ST. MARY'S
OF MICHIGAN

Comment : Requested NRC license # 21-03646-03 information (Control # 315515).

RE: Control# 315515

St. Mary's of Michigan
Ambulatory Care Center
Nuclear Medicine

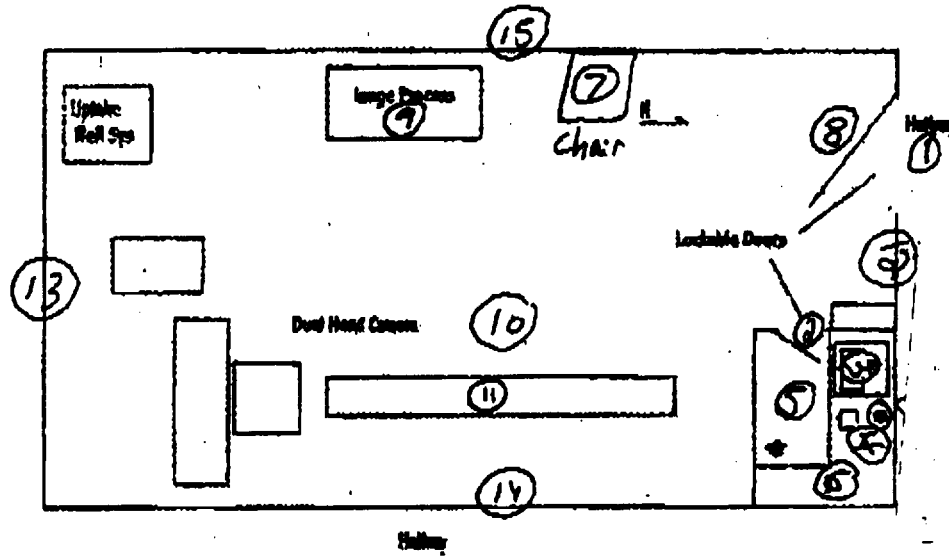
- a. Please confirm that you did not have any history of leaking sealed sources.
- b. Sorry, I'm confused by the close-out survey information you submitted. The areas on the close-out survey do not appear to match the sketch of the old nuclear medicine department. For example, it appears from the sketch that area 1 is the dose preparation area, however, the survey information dated May 2, 2006, indicated area 1 as the hallway. Area 2 on the sketch is the dose calibrator, however, the survey results indicated area 2 as the Hot Lab Door, etc. Again, please submit a diagram of your old nuclear medicine department with survey and wipe test results keyed to specific locations.

During the close out of this hot lab our consulting physicist instructed staff to conduct a close out survey process. The diagram has been renumbered to reflect the close out survey that was conducted. I am faxing a copy of the updated diagram.
